# SERVICE NO. 1218 LETTER

#### CREW SEAT CONTROL CABLE MODIFICATION

**PURPOSE:** In 2015, a production design change was incorporated into current production

airplanes to extend the life of the cable controlling the fore and aft movement of the crew seats. This service letter makes the design change available for the

Figure 1, Sheet 1 of 2
Crew Seat Adjustment Cable Installation

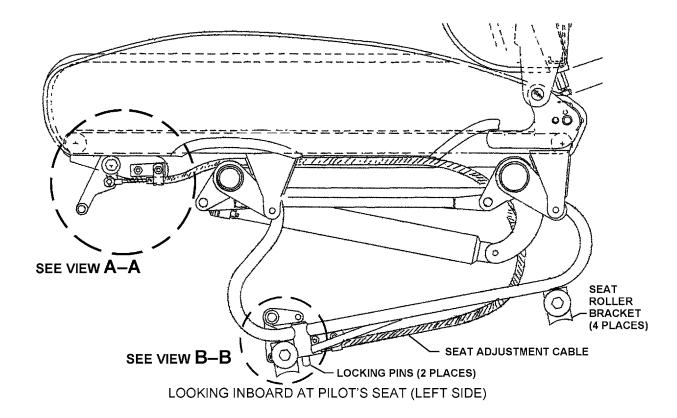
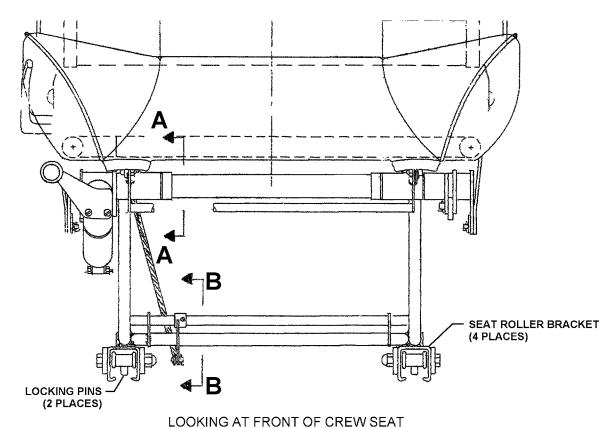
- 1. The modification consists of replacing the existing seat platform support plate (P/N 76356-002) with a longer version (P/N 76356-003) which limits aft travel of the seat release handle assembly. If the seat release handle assembly is allowed to freely travel aft it can cause the adjustment cable to kink which contributes to unnecessary wear on the cable and shortened service life. Some of the associated hardware is also replaced.

- 2. The following steps address replacing the cable in one seat (refer to Figure 1):
  - a. Remove and discard the old adjustment cable.
  - b. Install the new adjustment cable as follows:

- Cut the new spring (Piper P/N 487-490) in half.
    - 2) Install a half of the spring onto the upper end of the new adjustment cable: Rotate the cut end of the half spring onto the cable, and continue to rotate the half spring until it is on the cable as shown in View A–A.

- 3) Route the cable as shown in Figure 1. Take care to ensure the upper and lower ends are correctly positioned.
- 4) At the bottom right side of the seat base assembly, capture the cable with the P-clamps and loosely install the P-clamps to the seat bottom base assembly with screws, washers, and nuts.

- Position the cable housing end as shown in View B–B and secure in place by tightening nuts evenly at the P-clamps.
- 6) Connect the cable to the seat release arm by installing the pin, washers, and cotter pin.

Figure 1, Sheet 2 of 2
Crew Seat Adjustment Cable Installation

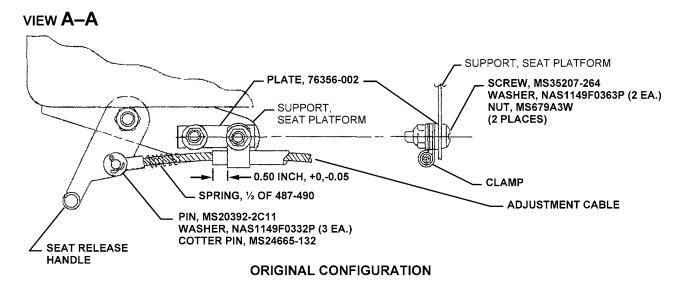
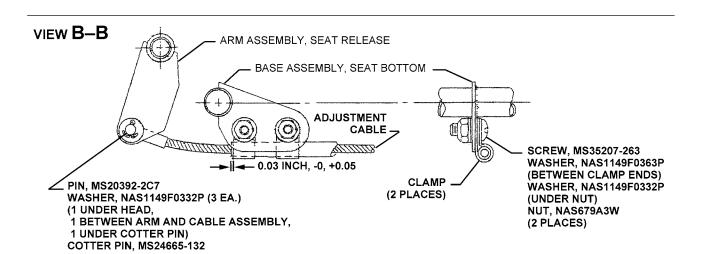
- 7) At the upper right side of the seat base assembly, capture the cable with the P-clamps and loosely install the new plate (P/N 76356-003) and P-clamps to the seat platform support with screws, washers, and nuts.

- 8) Position the cable housing end as shown in View A–A and secure in place by tightening nuts evenly at the P-clamps.
- 9) Connect the cable to the seat release handle by installing the pin, washers, and cotter pin.
